19/13-1-95B Madeline V. Waters Hse.
Wisteria/Rt. 118 (NTW Site) *pas*

HISTORIC PRESERVATION COMMISSION STAFF REPORT

Resource: Madeline V. Waters House

PROPOSAL: Construct new building

COMMEMORATIVE PLAQUE CONCEPT

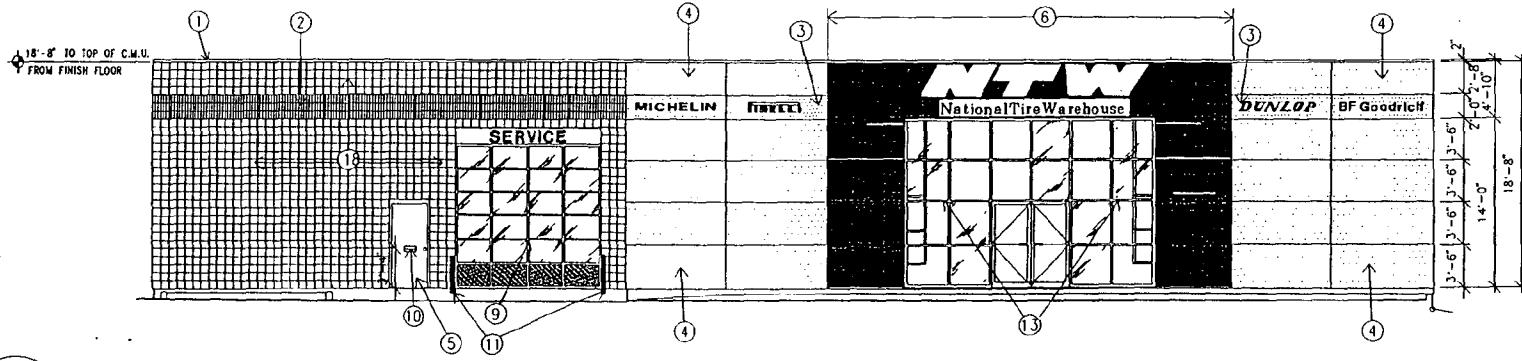
well as historic information. Staff suggests that the reference line be deleted from the historic marker, as this is not a verbatim quote from Ms. Sodeberg's book, but rather specific language developed for this marker.

- 1) Staff works closely with the Plan Review process to assure that the linear park design and planting plan is consistent with the Germantown Master Plan, and provides a welcoming park for pedestrian use which will encourage recognition of the historic past of this site.
- 2) ~~The signs~~ on the elevations facing MD. 118 and the rear of the building will not be ~~lighted signs~~.
- 3) The reference line will be deleted from the historic marker.
- 4) The monument for the historic marker and the retaining wall in the linear park will be constructed of stone, either recovered from the site of the Madeline V. Waters House or from a similar stone.

1 FRONT ELEVATION

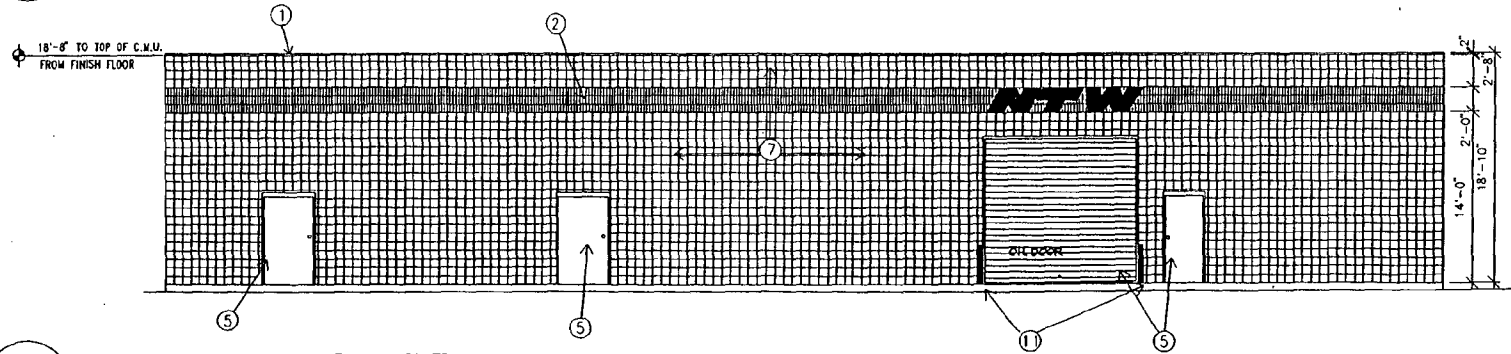
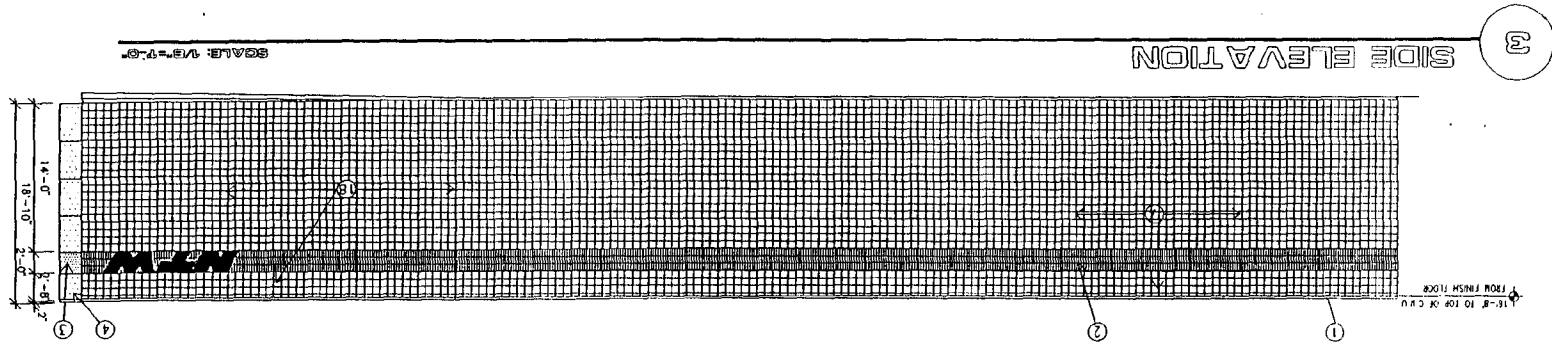
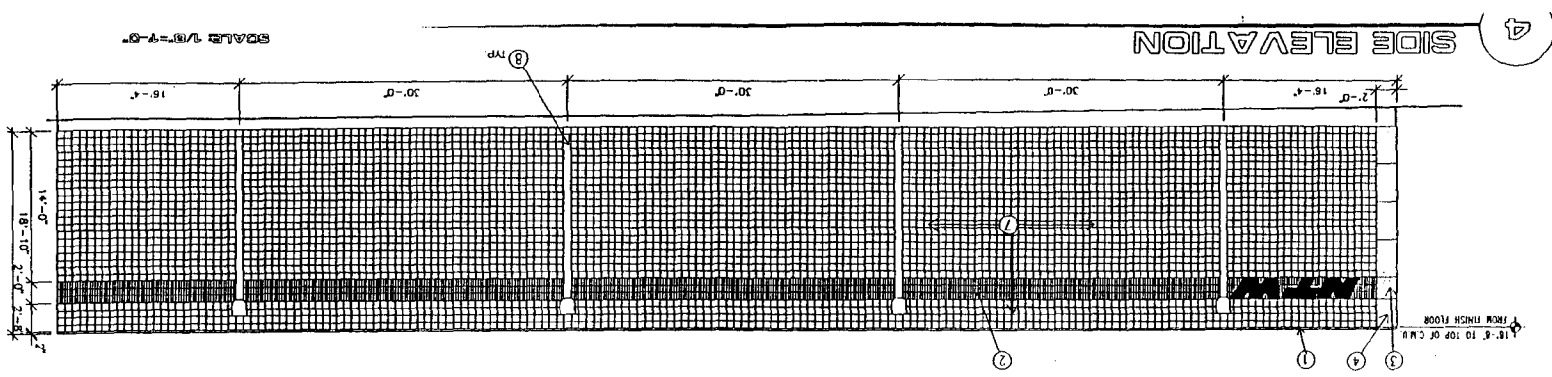
The large, entrance sign, which utilizes the bright yellow NTW letters in a black field over the glazed entrance is proposed on the front elevation which faces Wisteria Drive. It will not be visible from the Germantown historic district area. Smaller "NTW" signs are proposed for the remaining three facades of the building.

These smaller signs are proposed to be back-lit. This may be of concern on the rear and side elevation facing the existing Rt 118, because these elevations may be visible from the Germantown Historic District. The topography of this area should be taken into account for the NTW building will be placed at the high point of the site (as was the Madeline V. Waters House), and therefore will be highly visible from the surrounding area. The Germantown Historic District also climbs up a hill, and therefore the NTW building will be a prominent feature looking north from the District.

18 MS. ZIEK: Excuse me, just to clarify. Does the
19 Commissioners feels that -- in item 2 that the sign facing
20 118 is a problem that it shouldn't be a lighted sign? I
21 mean, I'm just backing off on my own recommendation.

24 MR. CLEMMER: I'm sorry, then I misunderstood you
25 because I was going by what you said, I had forgotten -- I
was concentrating on the stones. That number two be deleted

1 -- condition number two be deleted. Thank you.

COMMEMORATIVE PLAQUE & STONE MONUMENT DETAIL

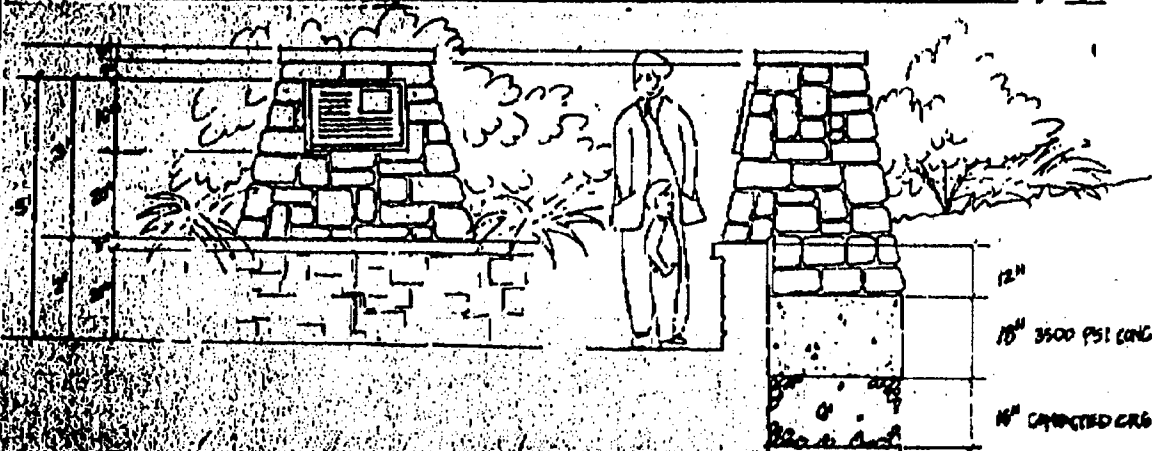
WORKING CHECKED & IS OK FOR CONSTRUCTION

O.K.
Gwen Wright
10/21/96
